**STATE OF NEW MEXICO
ENERGY, MINERALS AND NATURAL RESOURCES DEPARTMENT
OIL CONSERVATION DIVISION**

APPLICATIONS OF CIMAREX ENERGY CO. FOR COMPULSORY POOLING, LEA COUNTY, NEW MEXICO

APPLICATIONS OF DEVON ENERGY PRODUCTION COMPANY, L.P. FOR COMPULSORY POOLING, LEA COUNTY, NEW MEXICO

NOTICE OF CIMAREX'S POST-HEARING EXHIBIT SUBMITTAL

Revised Tract Map/Ownership For Cimarex Coriander Units-Post Conoco Trade*

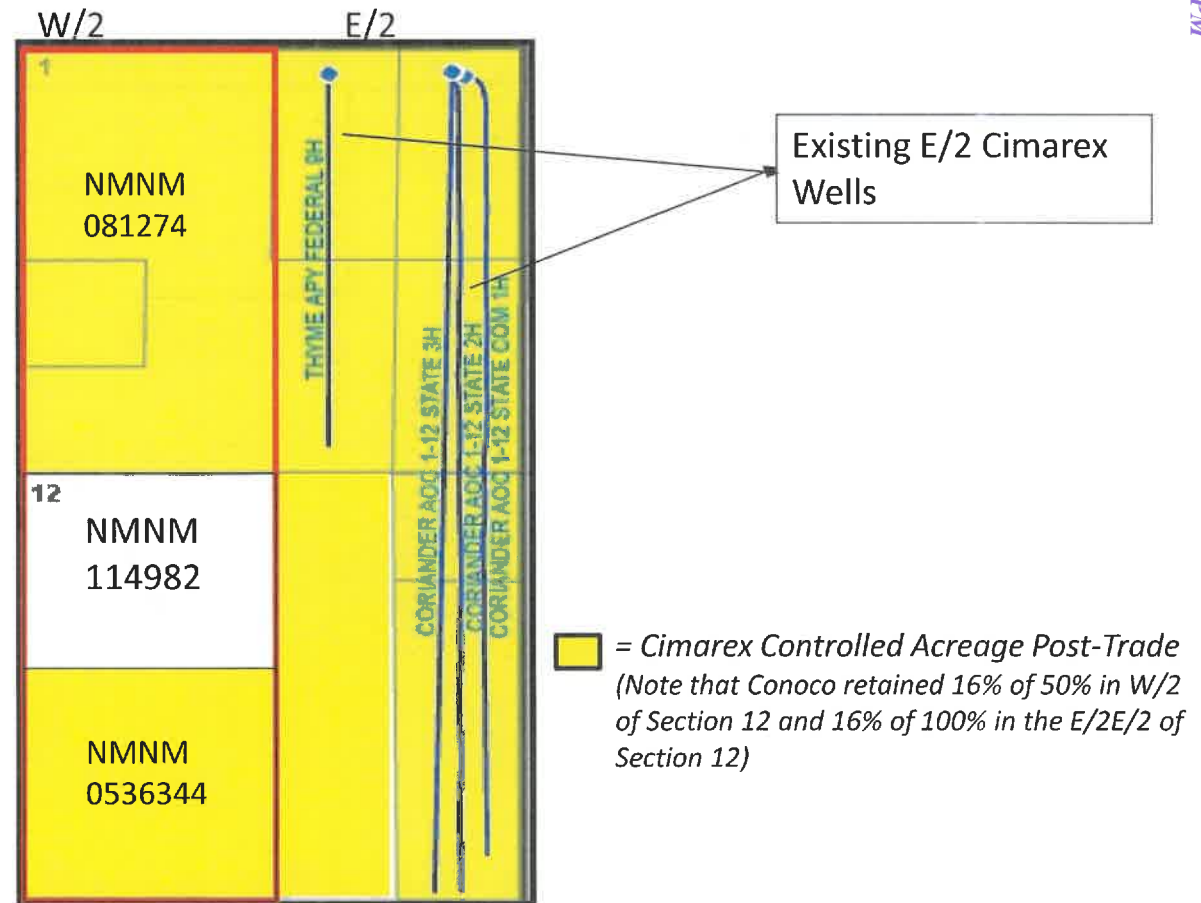
*Revised B-9: Revised to update ownership in SW/4 of Section 12 and to reflect Cimarex controlled acreage post-trade. Revisions in italics.

South Lea County Wolfcamp Well Count by Lateral Length - 720 sq. mile AOR

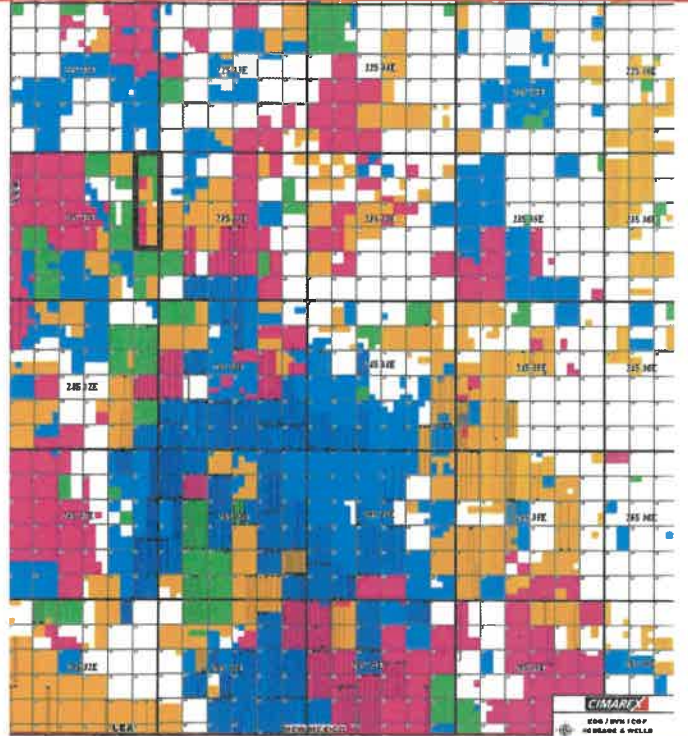
Engineer Slides D-12, D-13, D-14, and D-15-A replace existing Engineering Slides D-12, D-13, D-14, and D-15-A.

Devon Long lateral Wells > 2mile vs. EOG and Cimarex 1 to 2 mile (updated)

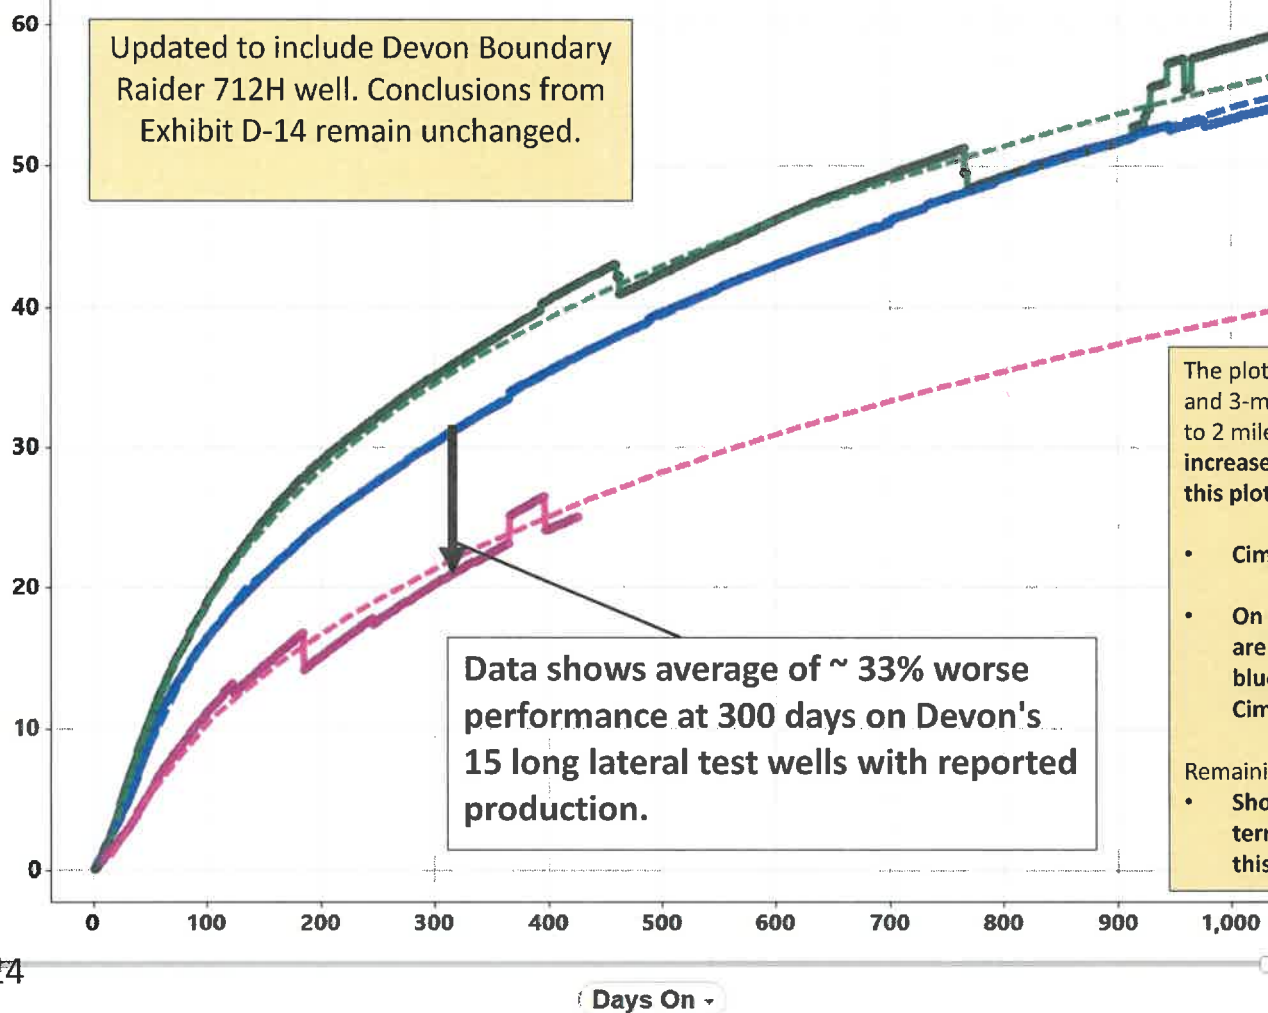
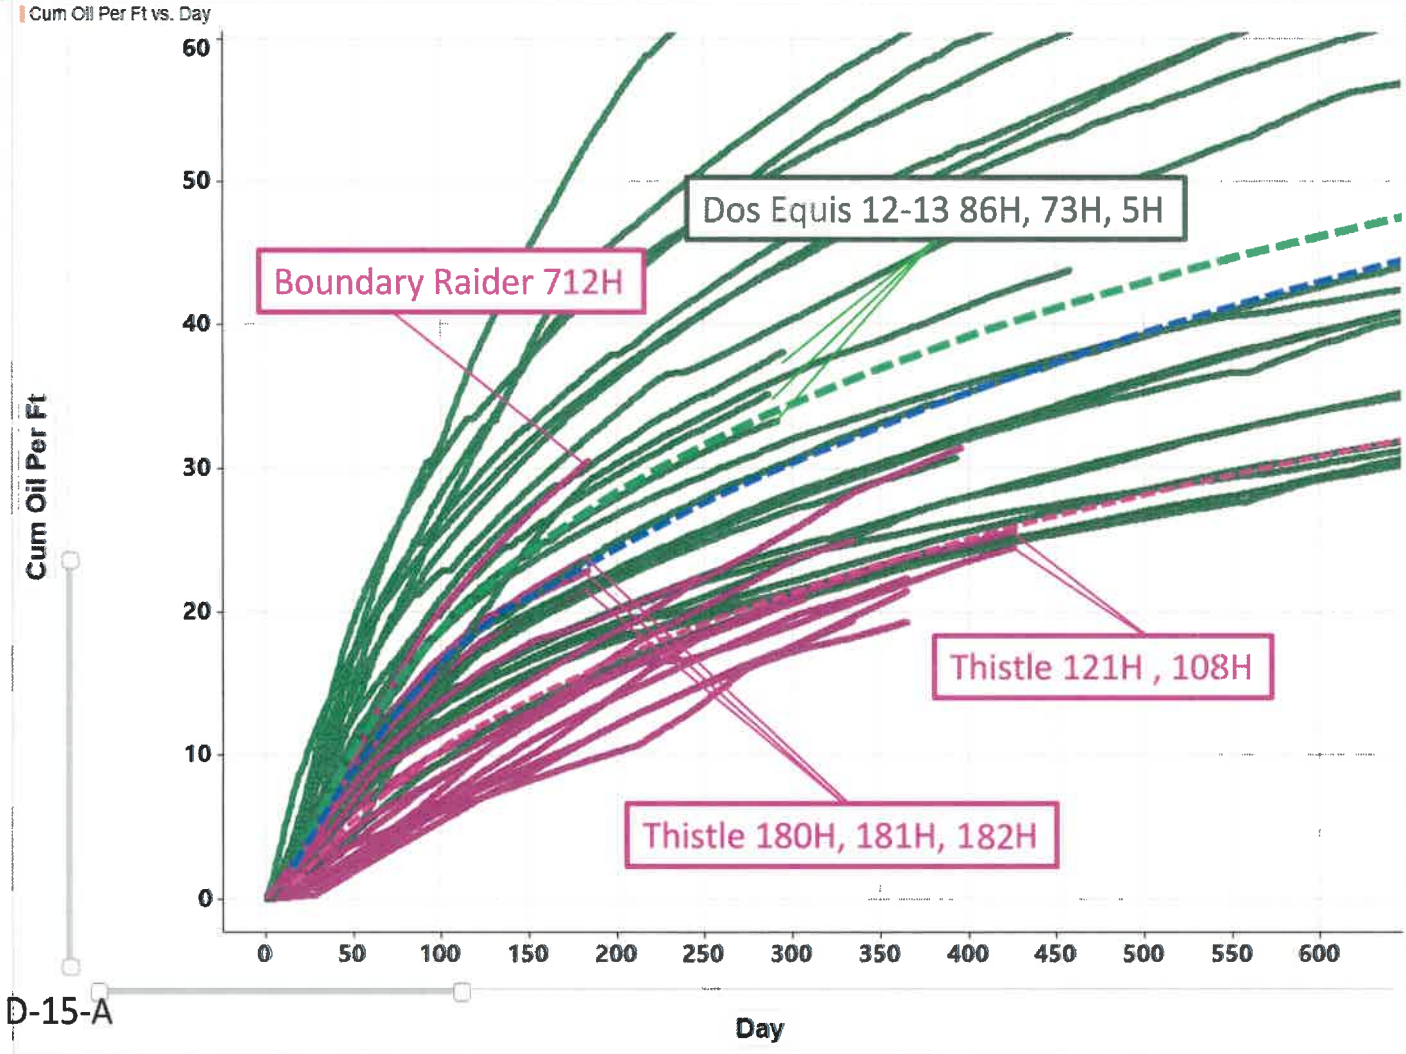
Updated to include Devon Boundary Raider 712H well. Conclusions from Exhibit D-14 remain unchanged.
